# F/CMVSS Noncompliance Recall

## N192218960 Incorrect Rear Quarter Glass

**Release Date:** June 2019

**Revision:** 00

### Short Wheelbase Vehicles (Model numbers G23405/G33405)

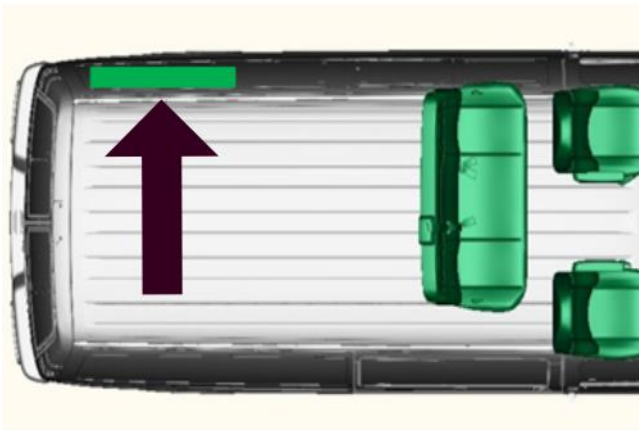
- Replace the **left and right** rear quarter glass windows. Refer to *Adhesive Installation of Bodyside Stationary Windows* in SI.
